RESTRICTIVE COVENANT AMENDMENT REVIEW SHEET

CASE: C14-91-0015(RCA)
Champion Commercial Development

Date: April 12, 2011
To: Clark Patterson, Case Manager
CC: Kathy Hornaday, P.E., PTOE
HDR Engineering, Inc.
Reference: Champion Commercial Development, C14-91-0015(RCA)

RM 2222
PLAN & PROFILE

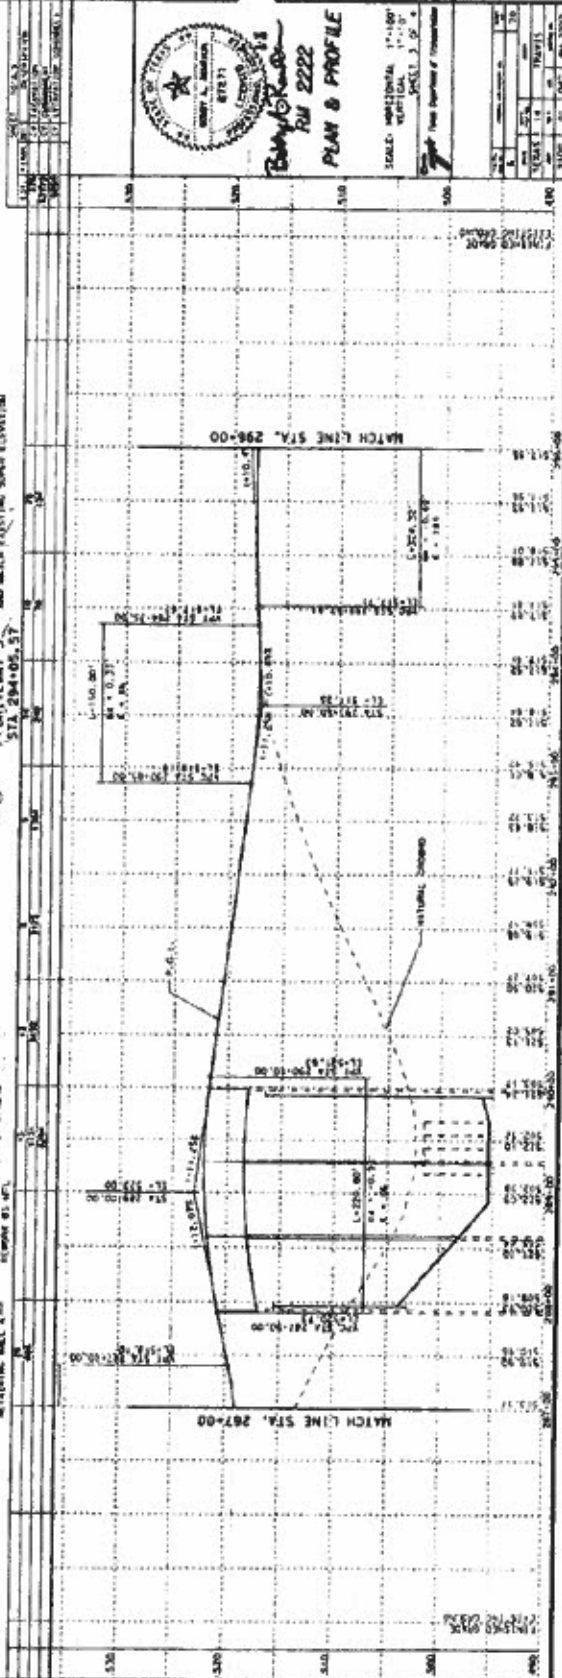
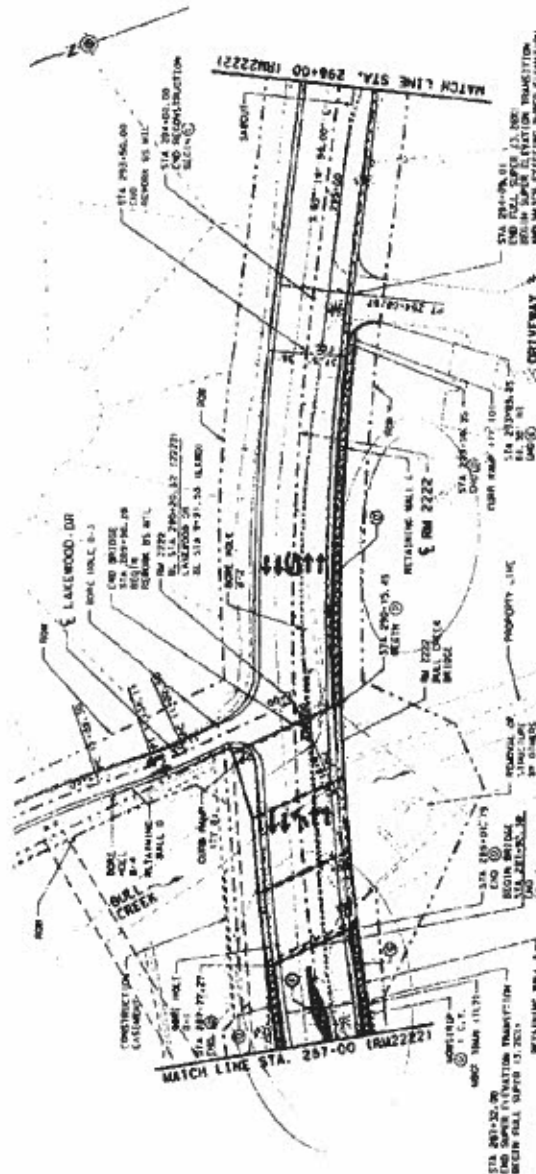
The second scenario assumed the conditions of this request for restrictive covenant amendment. In scenario two, a left turn bay provides left-turn access into the site for traffic from westbound RM 2222.

- 3) The City of Austin, subject to approval by TxDOT, reserves the right to make changes to the median, including closure, if required due to land use change, change in driveway volume or to provide protection for life or property on or adjacent to the roadway.

Sight Distance Calculations

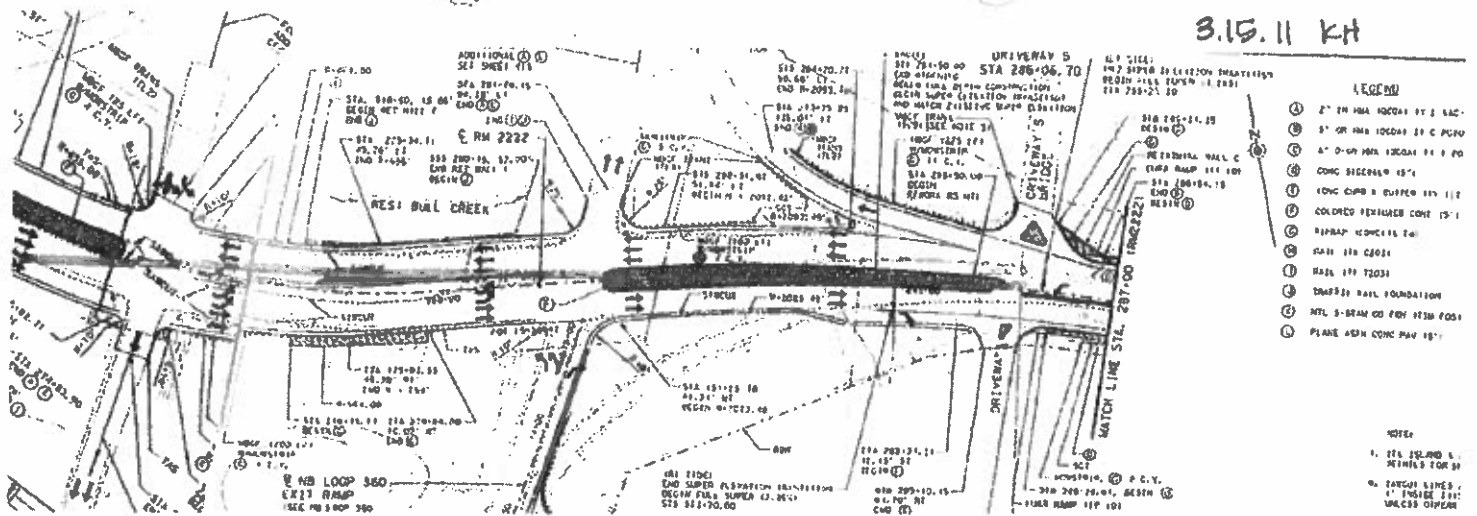
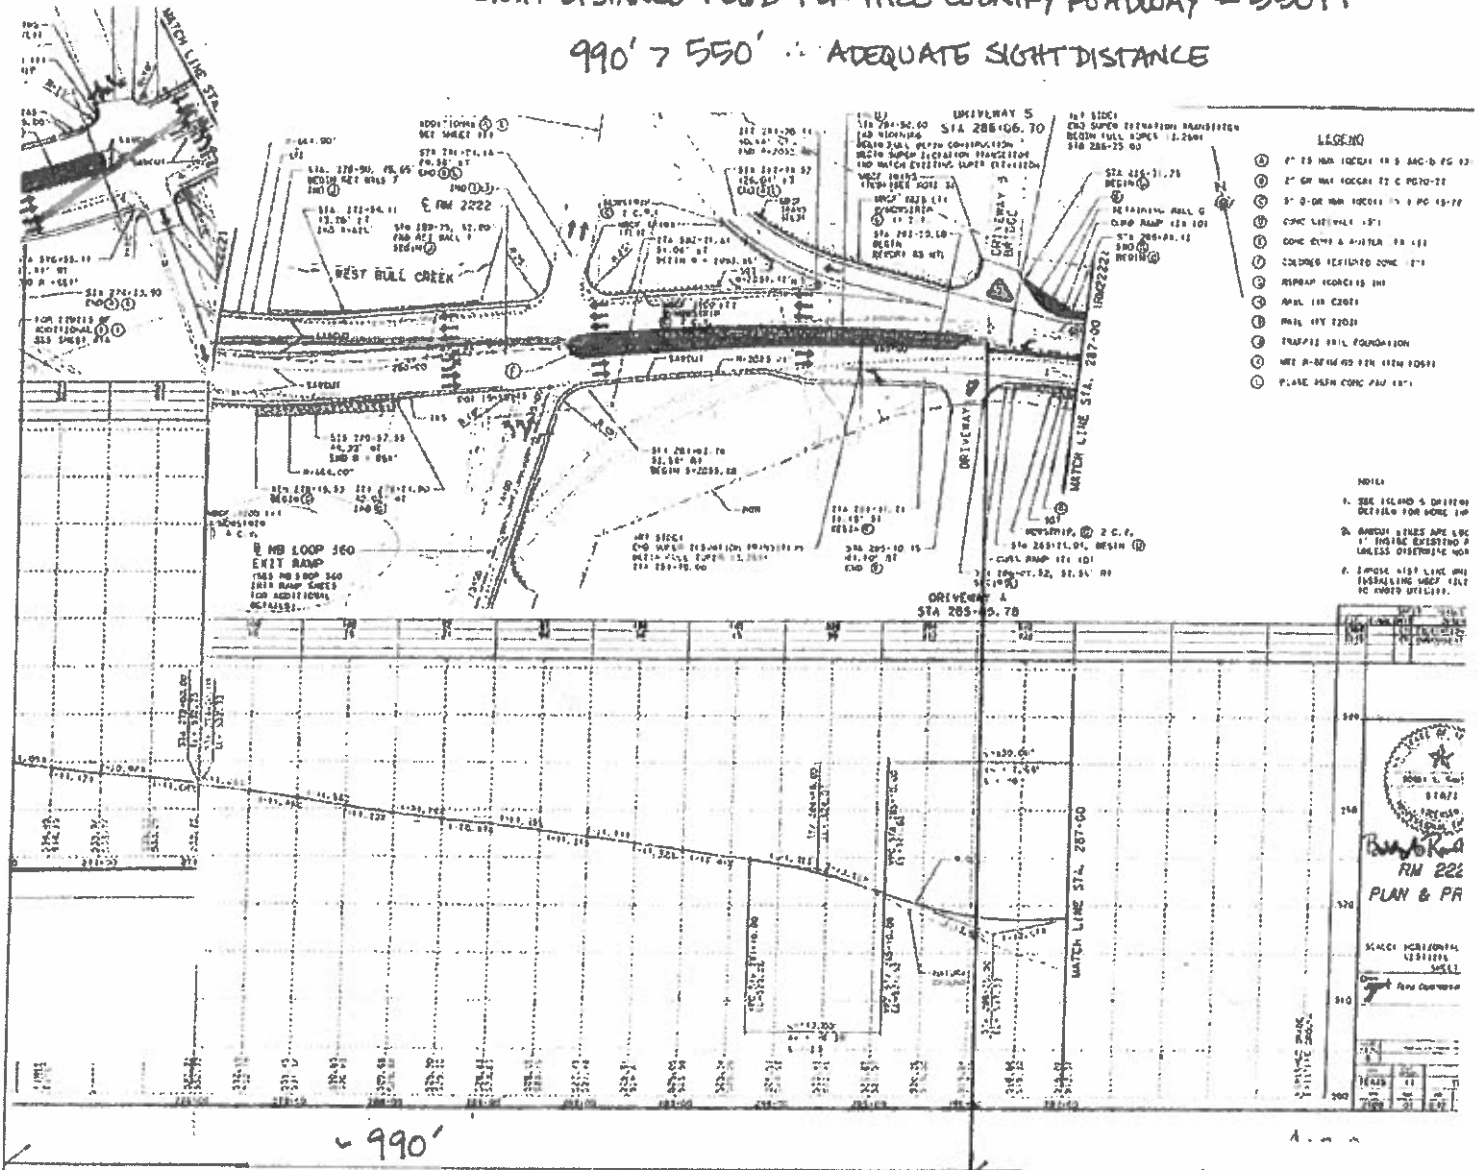
- SIGHT DISTANCE REQ'D FOR RIGHT TURN FROM A STOP, WITH 55 MPH DESIGN SPEED = 444 FT
- SIGHT DISTANCE REQ'D FOR LEFT TURN FROM MAJOR STREET, WITH 55 MPH DESIGN SPEED = 444 FT
- SIGHT DISTANCE REQ'D FOR HILL COUNTRY ROADWAY = 550 FT

990' > 550' ∴ ADEQUATE SIGHT DISTANCE

Figure 1
RM 2222 Proposed Lane Configuration

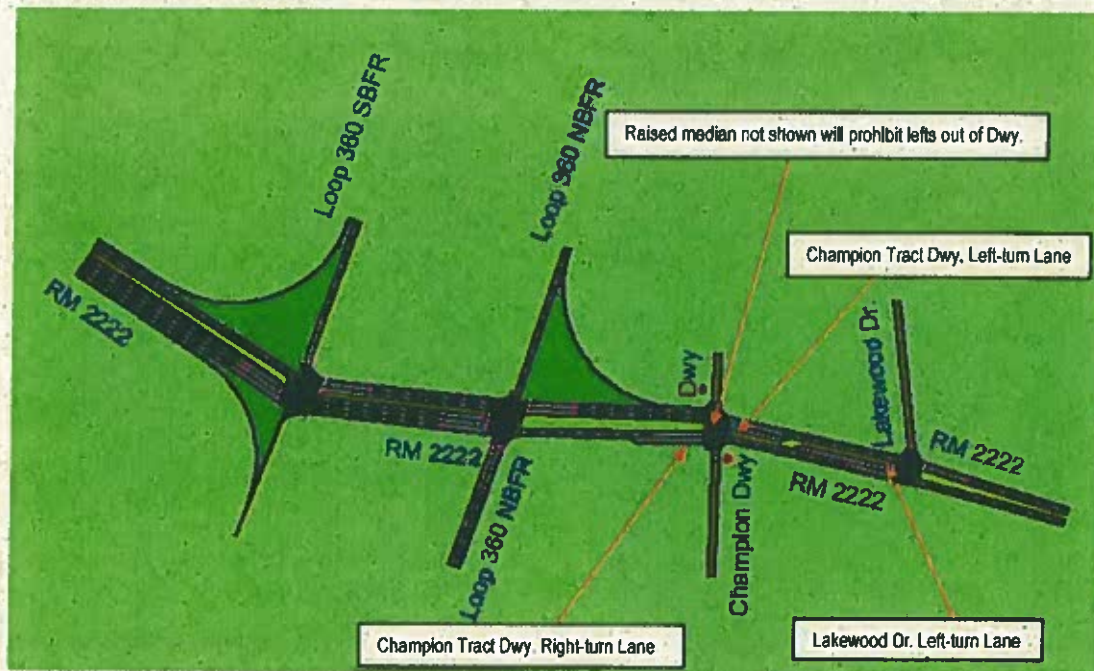
As shown in Figure 1, the Champion Tract driveway on RM 2222 will be aligned with an existing driveway to a retail center on the north side of RM 2222. This driveway is a right-in/right-out only driveway. Counts were not available for this location; therefore, traffic to and from this retail center was estimated given the land use present on the site, which includes 14,600 square feet of quality restaurant, 8,330 square feet of high turnover restaurant, and 4,070 square feet of shopping center. (Trip generation information is enclosed.) The retail center also has an access driveway (not depicted) on Loop 360 Northbound Frontage Road, north of RM 2222. For clarification, the 2007 turning movement counts used for this analysis do include traffic generated by this retail center, since it was occupied at that time; however, counts for the driveway itself are not available. Therefore, traffic from this retail center was not added to the intersections listed above.
